**SUBJECT:** **NEW VEHICLE DEMONSTRATION / DELIVERY HOLD**  
**Safety Recall 23S49 - *SUPPLEMENT #1***  
**Certain 2023 Model Year F250-F350 with 10.5” Axle Shaft**  
**Left Axle Shaft Failure at Flange**

**NEW! REASON FOR THIS SUPPLEMENT**

- *Updated Technical Instructions*
- *Updated Labor Allowances*

## CERTAIN 2023 MODEL YEAR SUPERDUTY VEHICLES EQUIPPED WITH A SINGLE REAR WHEEL (SRW) 10.5 AXLE — LEFT AXLE SHAFT FLANGE INSPECTION

**FIGURE 1**

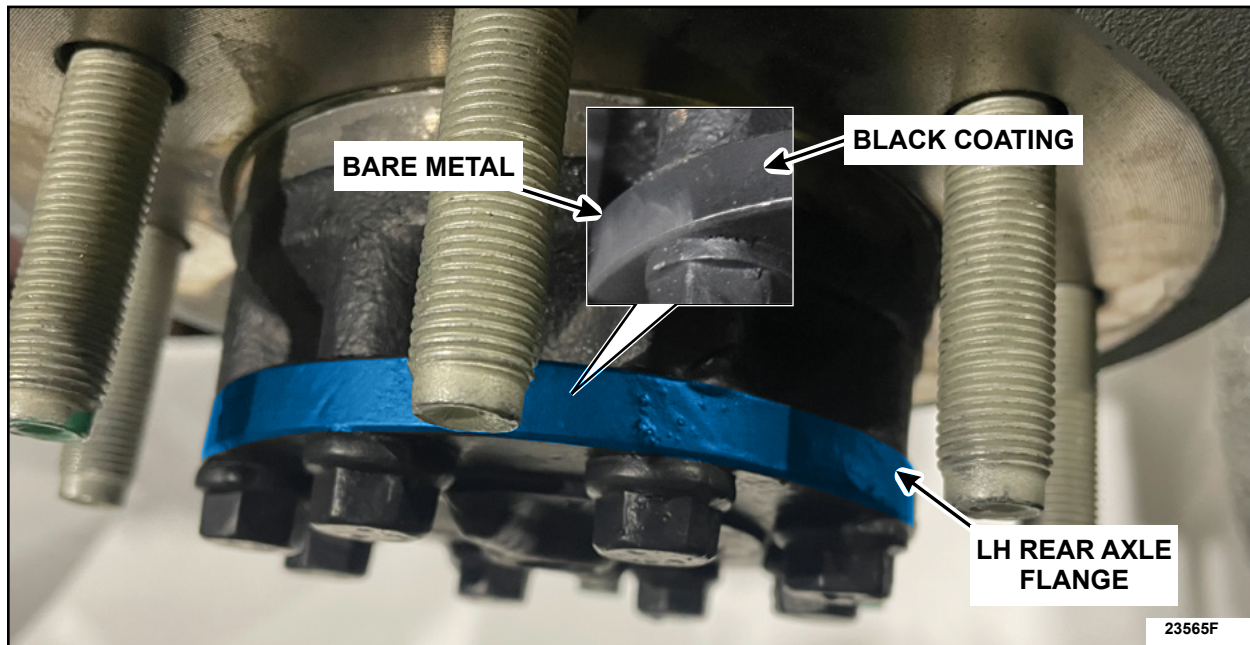
*2. Using a right angle grinder with a wire wheel, apply light pressure and remove the black coating on the LH rear axle flange to expose the bare metal. See Figure 1.*
